MEETING AGENDA
SAN ONOFRE UNITS 2 & 3 PRESSURIZER SAFETY
VALVE INLET PIPING MODIFICATIONS 9 - 16 - 81

SAFETY VALVE SYSTEM MODIFICATION

DRESSER 31709NA RESULTS

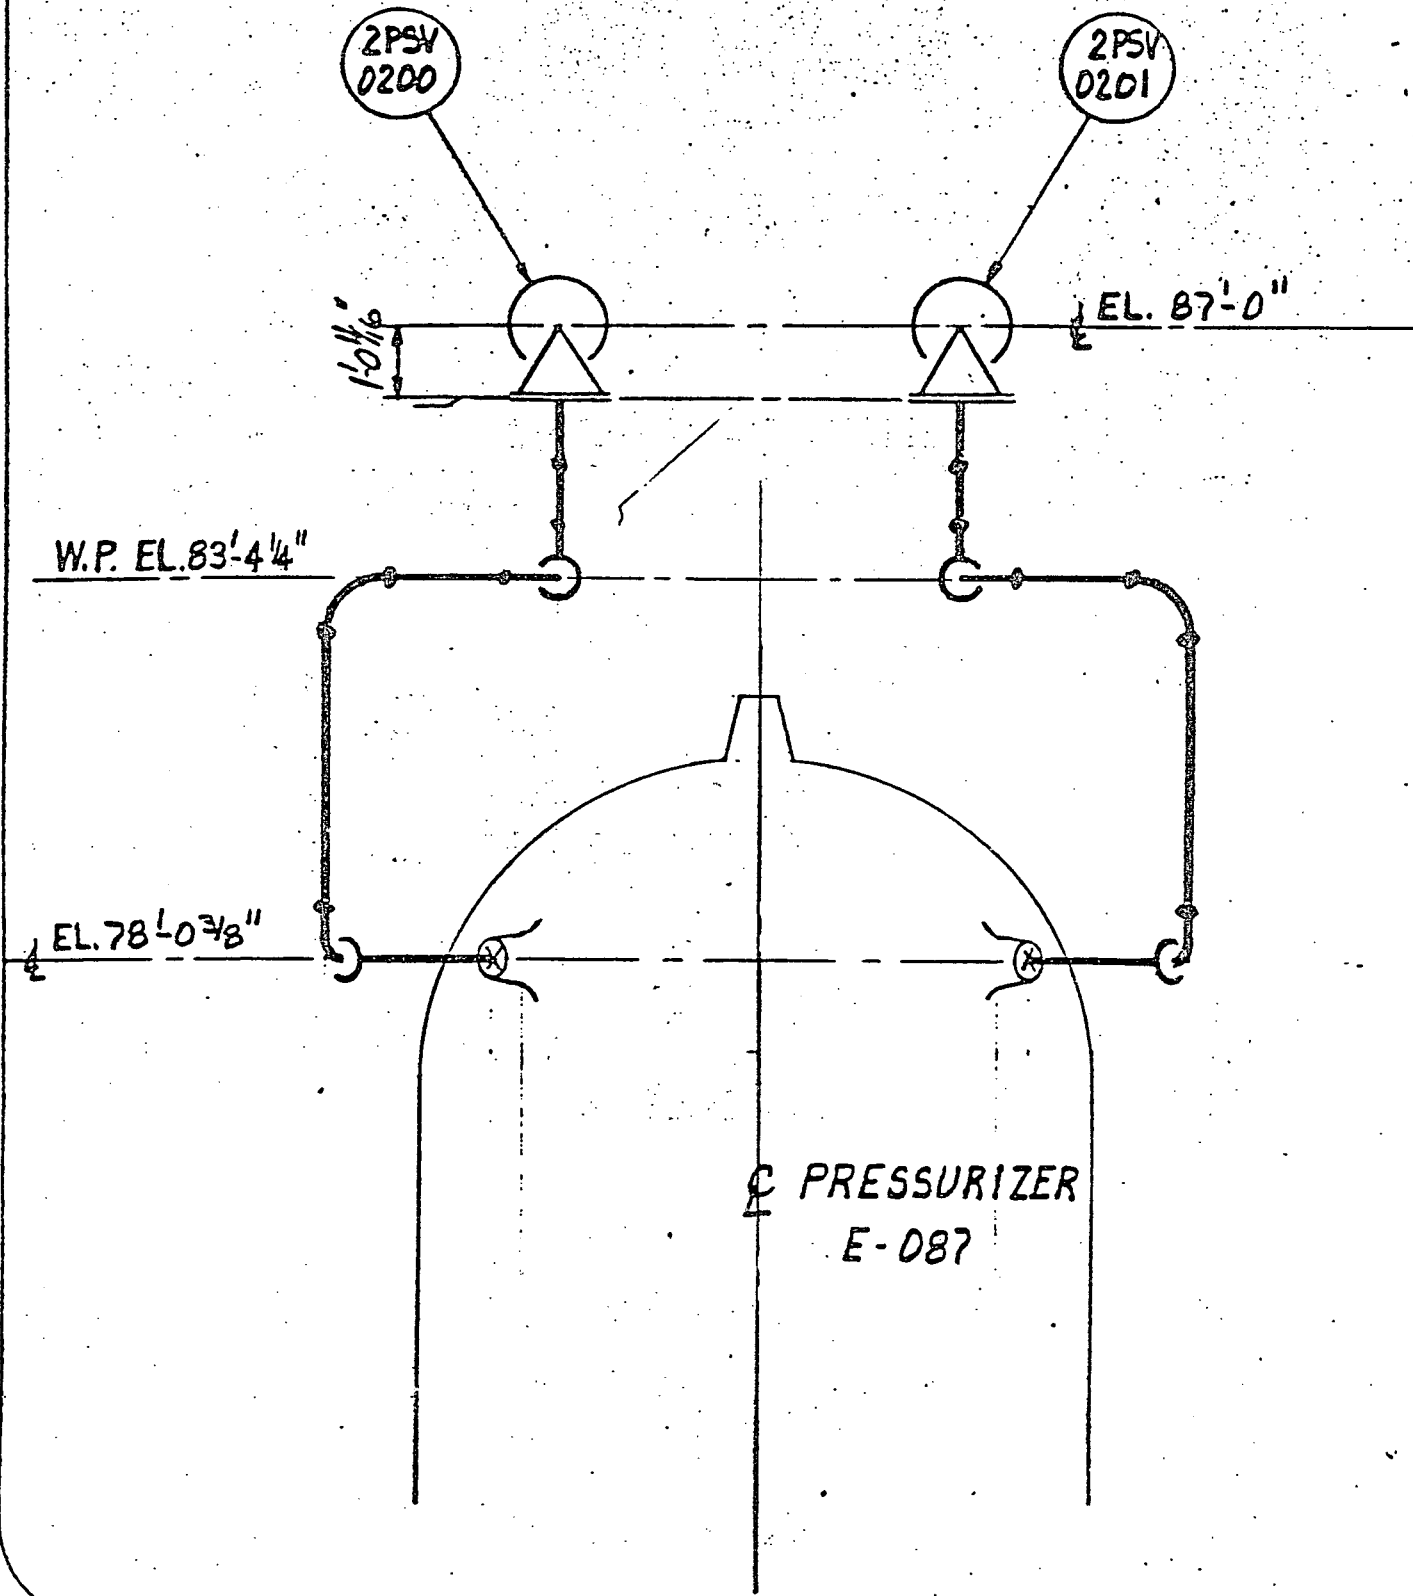
DATE:	JUNE 2, 1981
TEST DESCRIPTION	HIGH RAMP RATE STEAM TEST DESIGNED TO PRODUCE 2700 PSIA PEAK PRESSURE FOLLOWING VALVE LIFT.
INLET PIPING:	~ 15 FT
OPENING PRESSURE:	2488 PSIA
OPENING TIME:	0.016 SEC
PEAK PZR PRESSURE:	2680 PSIA
CLOSING PRESSURE:	2010 PSIA
POST-TEST LEAKAGE:	0.53 GPM
COMMENTS:	1) CHATTER AT 36 HZ FOR 122 SECONDS. 2) ORIGINAL RING ADJUSTMENT FOR 3% BLOWDOWN.

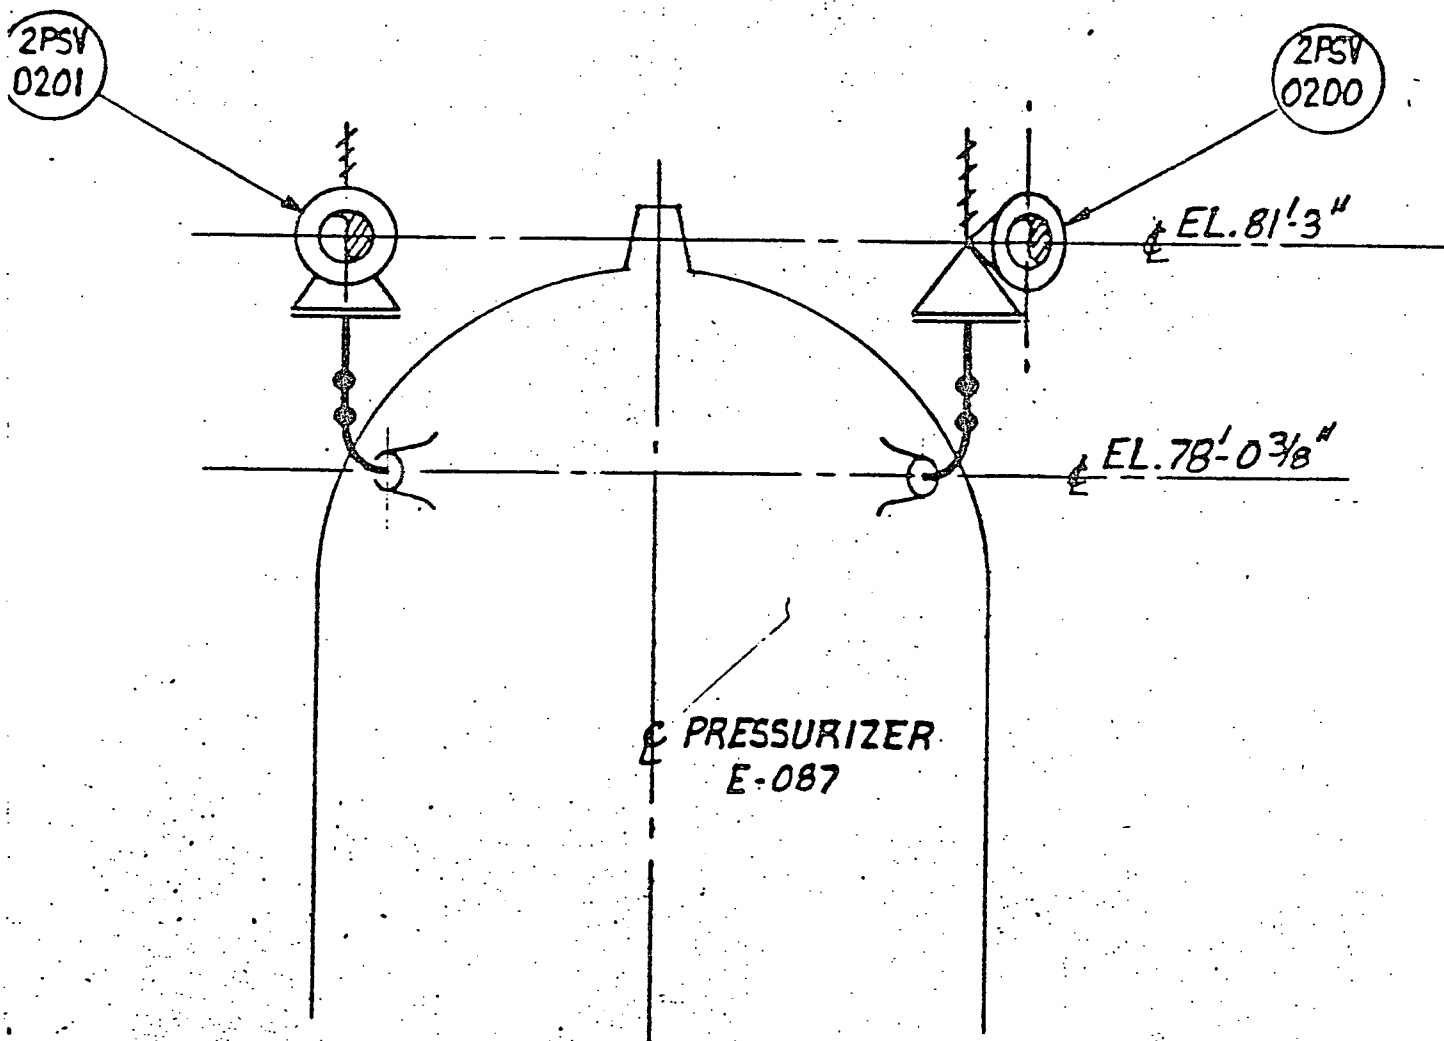
SHORTEN INLET PIPE

ADJUST VALVE RING SETTINGS

EXISTING ARRANGEMENT

NEW ARRANGEMENT

SHORTEN INLET PIPING
INCREASE BLOWDOWN SETTING
